# UNITED STATES PATENT AND TRADEMARK OFFICE

APPLICATION NO.	FILING DATE	FIRST NAMED INVENTOR	ATTORNEY DOCKET NO.	CONFIRMATION NO.
10/784,011	02/23/2004	Gregory Alan Judge		2504
40992	7590	08/04/2005		
THOMAS R. LAMPE BIELN, LAMPE & THOEMING 1390 WILLOW PASS ROAD, SUITE 1020 CONCORD, CA 94520			EXAMINER SMITH, KIMBERLY S	
			ART UNIT 3644	PAPER NUMBER

# Office Action Summary

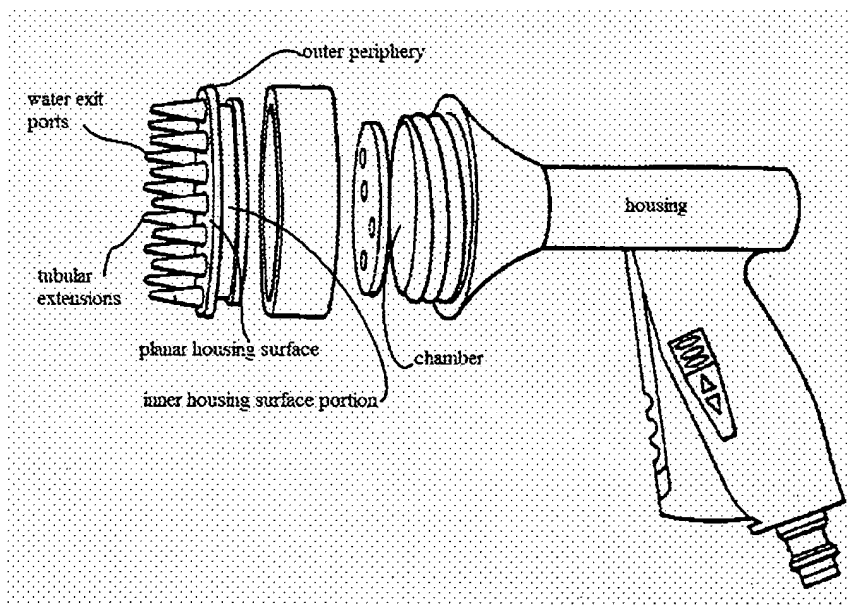
Frank discloses a handheld pet animal bathing utensil for connection to a source of pressurized water (at 18)

including a housing, chamber, outer periphery, planar housing surface, inner housing surface portion, water exit ports and tubular extensions (view

Figure at the right). Frank

discloses that the extensions are substantially co-planar or

may be of different lengths (column 3, lines 63-67). In the embodiment of Frank have differing lengths, the shorter of the two lengths are being defined the water exit ports and the longer are

being defined the tubular extensions. While Frank does not positively disclose the rigidity of the elongated tubular extensions, it is noted that extensions of different degrees of hardness may be used and as such, one of ordinary skill in the art would have found it obvious to make the extensions be rigid since it has been held that where the general working conditions of a claim are disclosed in the prior art, discovering the optimum or workable ranges involves only routine skill in the art. Frank discloses the extensions being free of openings along the sides thereof and having water discharge openings formed in the distal ends thereof (as viewed in Figure 4). Frank further discloses a control valve (20) operatively associated with the housing for controlling water flow through the exit ports and the water discharge openings. While Frank does not positively disclose the arrangement of the extensions/ports when of differing lengths, it is seen in Figure 4 that the extensions/ports are positioned along the entire length of the outer periphery of the housing. As such, it would have been obvious to one having ordinary skill in the art at the time the invention was made to arrange the extensions/ports in a given manner, since it has been held that rearranging parts of an invention involves only routine skill in the art.
